COLLIN COUNTY, TEXAS

ADDENDUM No. One (1)

IFB NO. 02180-10

Construction, Bridge: County Road 638 over Sabine Creek

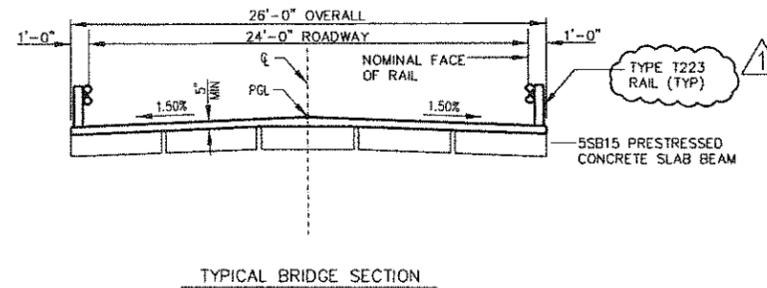
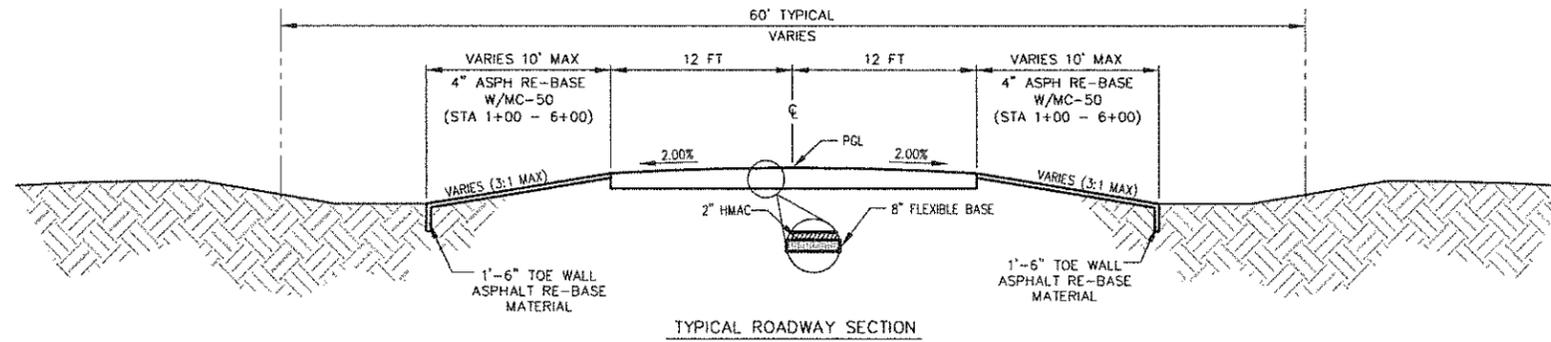
Changes made to Roadway Typical Section

1. Revised Railing Callout

NO.	REVISION	BY	DATE
COLLIN COUNTY, TEXAS DEPARTMENT OF PUBLIC WORKS BRIDGE BOND PROJECT			
BRIDGE LAYOUT CR 638 @ SABINE CREEK			
Charles Gojer and Associates, Inc. Consulting Engineers 11615 Forest Central Dr., Suite 303 Dallas, Texas 75243 (214) 340-1199 TX REGISTRATION NO. F-697

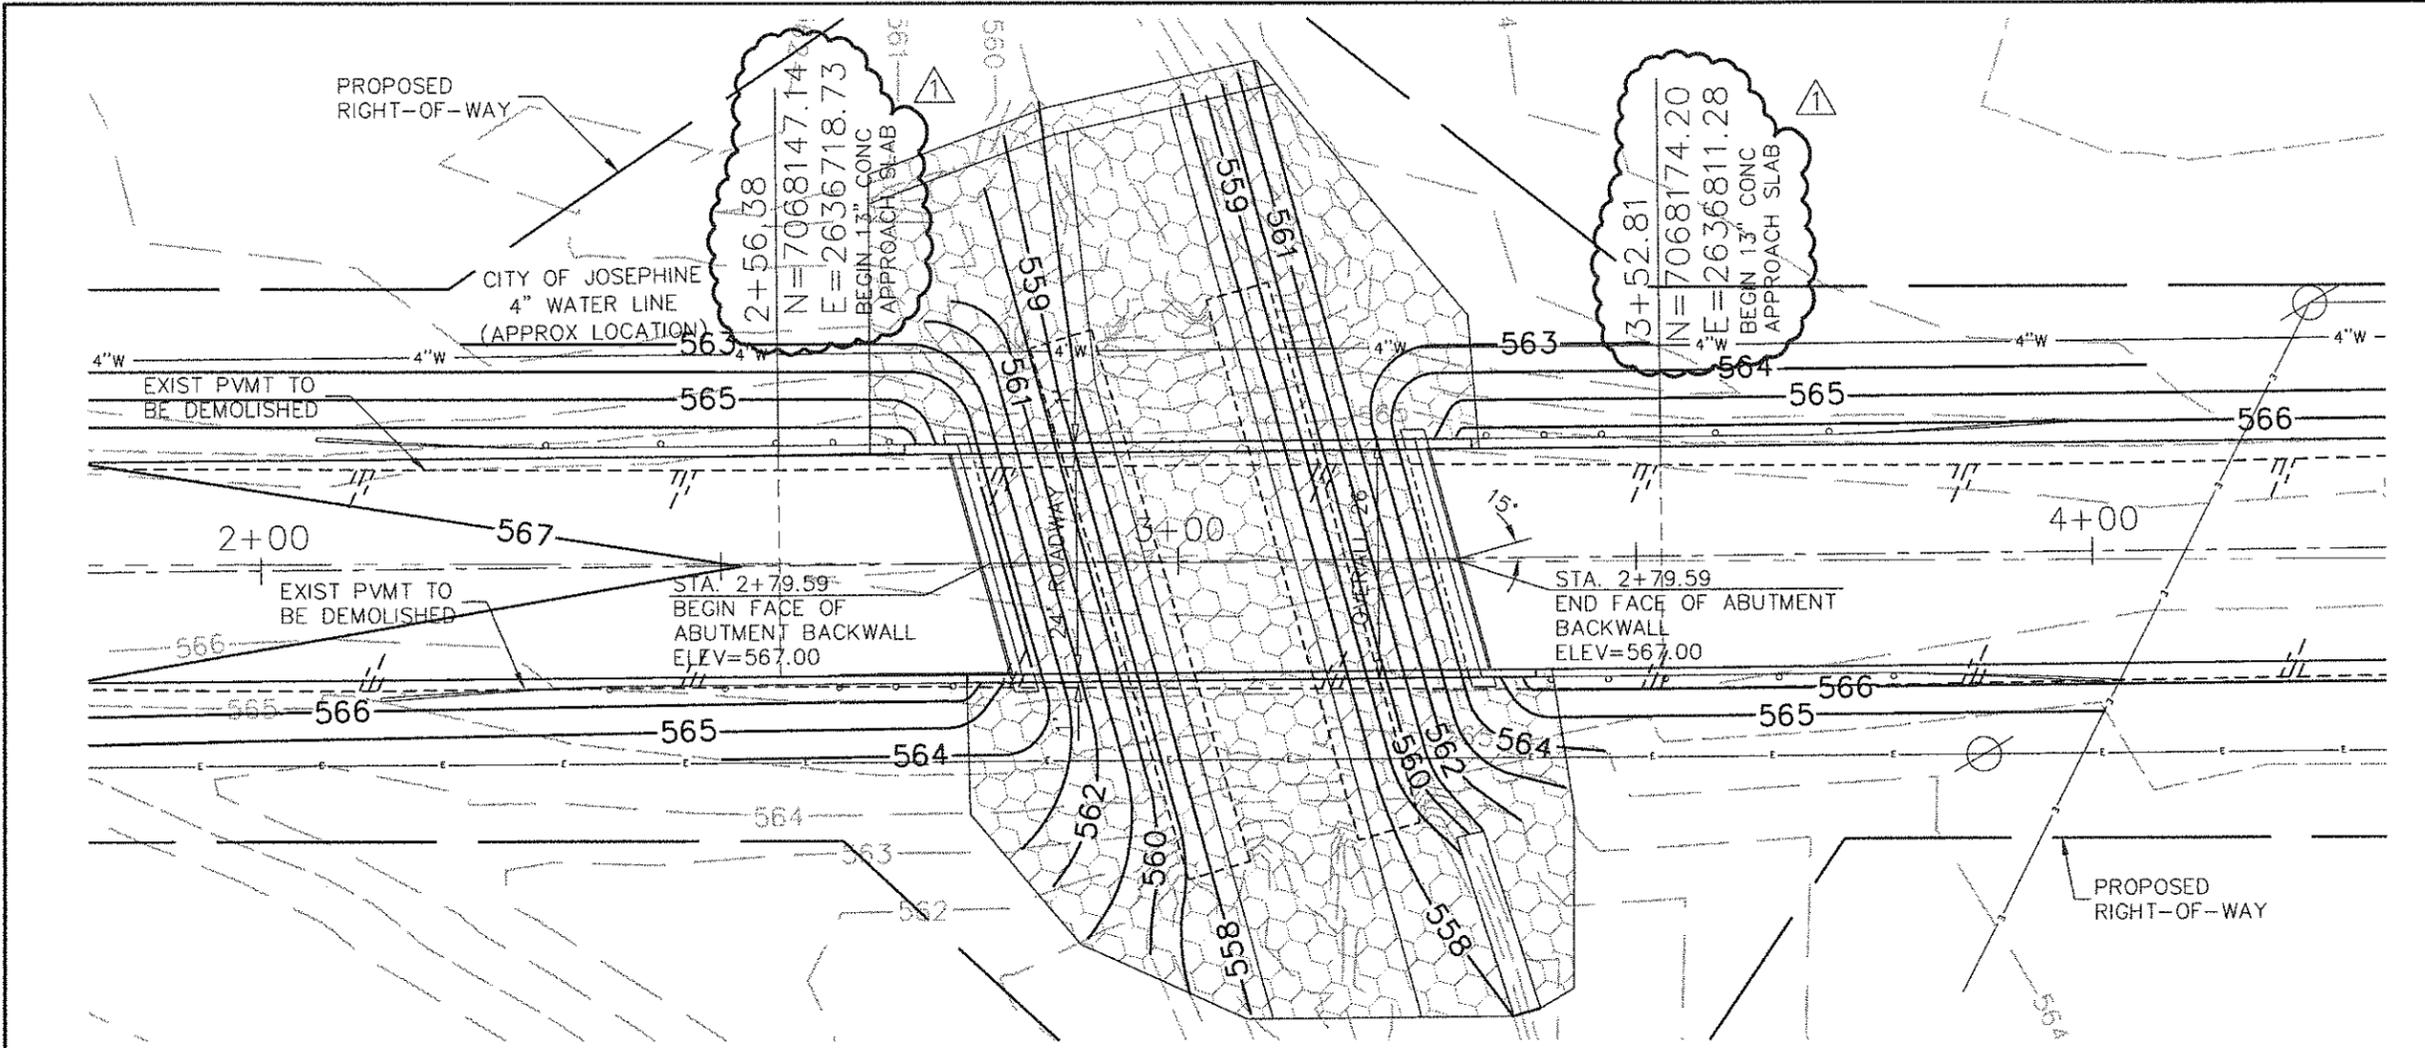
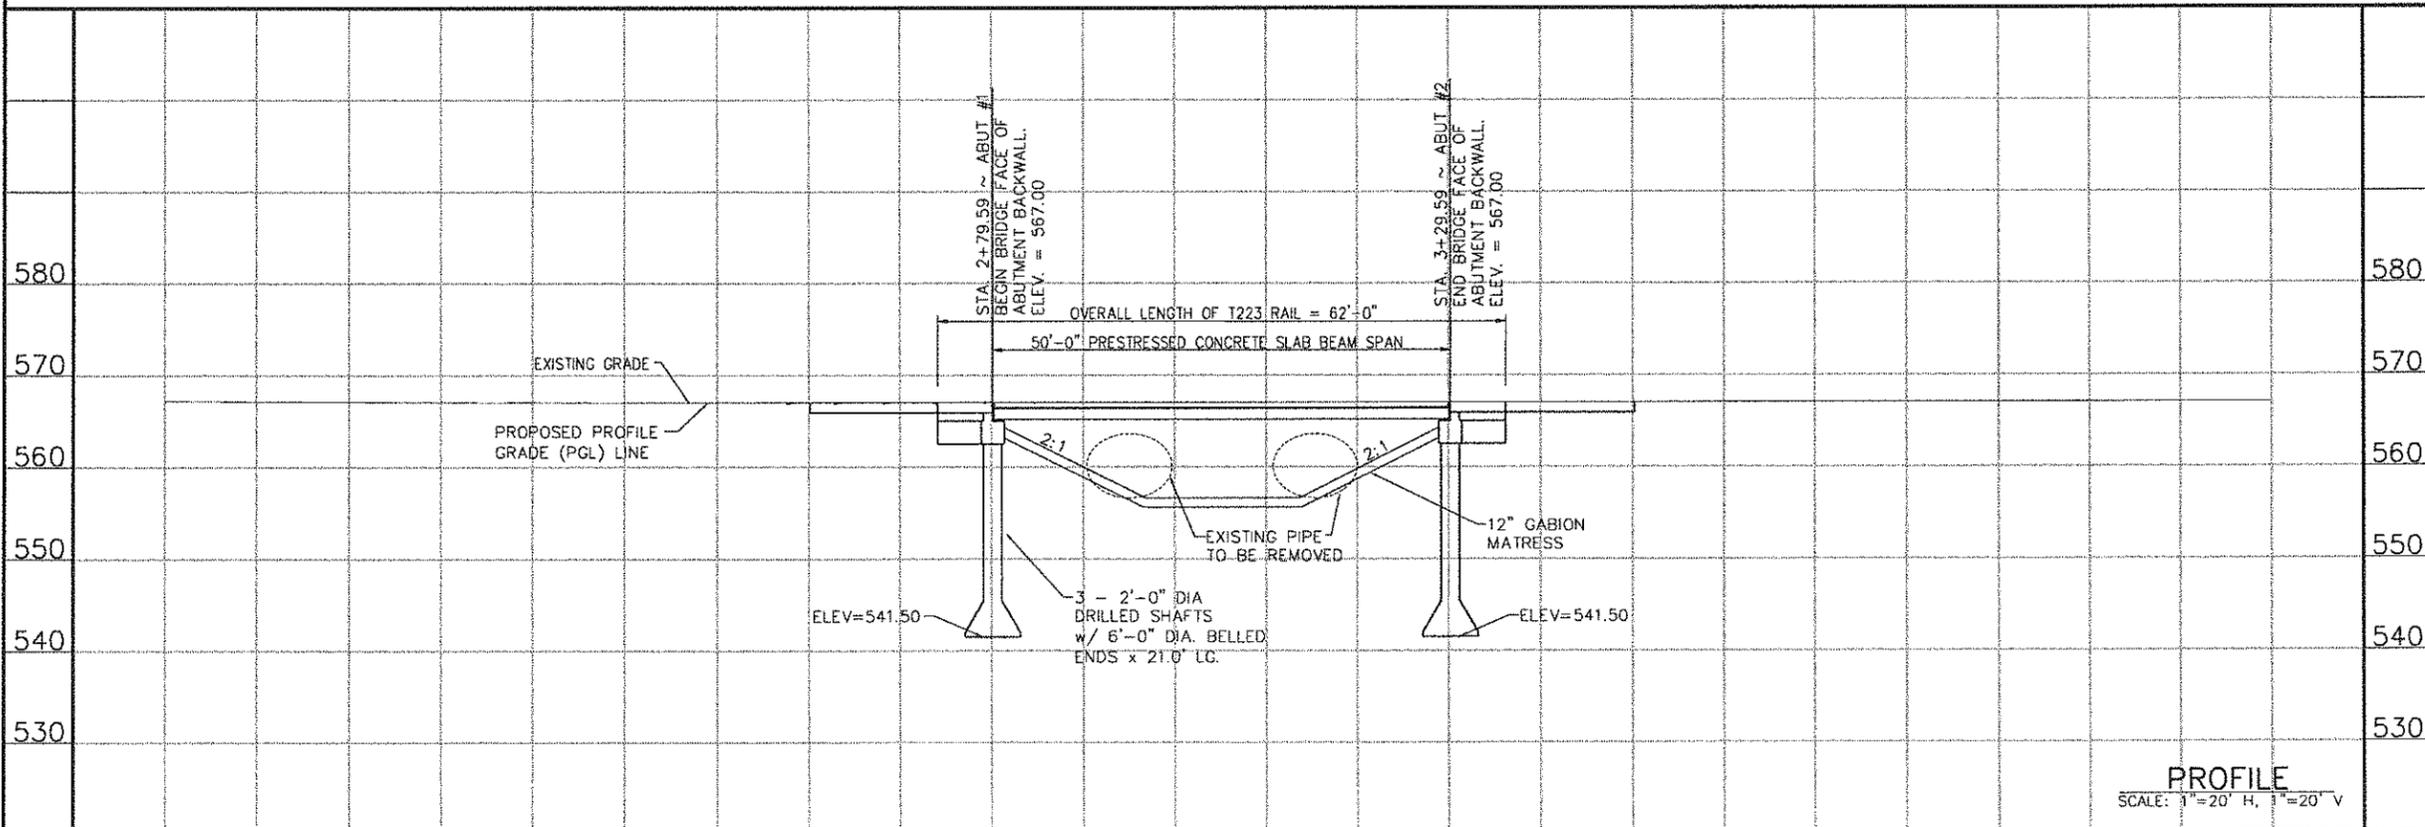
Changes made to Bridge Layout
1. Modified Approach Slab thickness.
